Access Compliance Report

Public Rights-of-Way

Intersection ID: 16132	Main Street: S_TRYON_ST	Cross Street: W_CAMA_ST	Location: NW
ADA ID: 1ECAF07F2369	Ramp Type: PerpDiag	Initial Pass/Fail: Fail	Overall Compliance: No
		Severity Score: 10

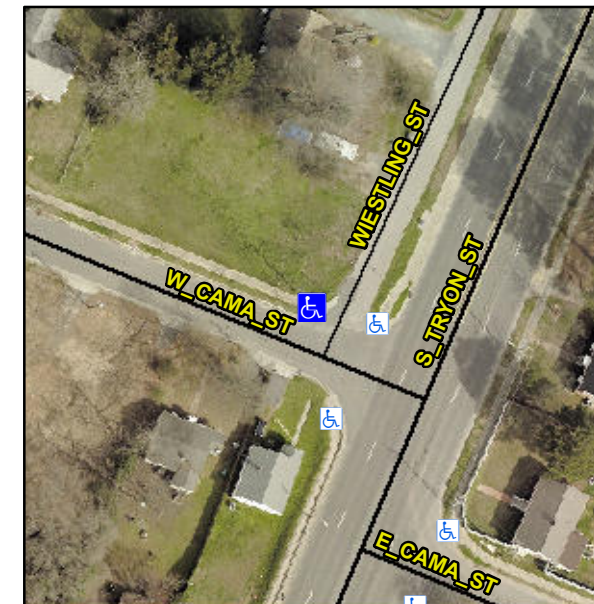
Not Found, R304.5.1, R304.5.3

Compliance	Description	Data	Compliance	Description	Data
N/A	Ramp Length (in)	45.0	Yes	Ramp Slope (%)	7.6
No	Ramp Width (in)	43.0	No	Ramp XSlope (%)	4.5
N/A	Flare Type LT	N/A	N/A	Flare Type RT	N/A
N/A	Flare Slope LT (%)	N/A	N/A	Flare Slope RT (%)	N/A
N/A	Flare Traversable LT?	N/A	N/A	Flare Traversable RT?	N/A
N/A	Landing Length (in)	N/A	N/A	DWS Provided?	N/A
N/A	Landing Width (in)	N/A	N/A	DWS Contrast?	N/A
N/A	Landing Slope (%)	N/A	N/A	DWS Length (in)	N/A
N/A	Landing X Slope (%)	N/A	N/A	DWS Full Width?	N/A
N/A	Landing Curb? (Y/N)	N/A	N/A	DWS Offset (in)	N/A
N/A	Shared Landing?	N/A			
N/A	Gutter Ponding?	N/A	N/A	Gutter Slope (%)	N/A
N/A	Gutter Lip Ht (in)	N/A	N/A	Gutter X Slope (%)	N/A
N/A	Painted X Walk1?	No	N/A	Painted X Walk2?	No
	X Walk 1 Direction	To S		X Walk 2 Direction	To SE
N/A	X Walk 1 Width (in)	N/A	N/A	X Walk 2 Width (in)	N/A
	X Walk 1 Slope (%)	2.4		X Walk 2 Slope (%)	2.2
	X Walk 1 X Slope (%)	2.2		X Walk 2 X Slope (%)	5.8

Remove & Replace Curb Ramp With Two New Directional Ramps or Equivalent.
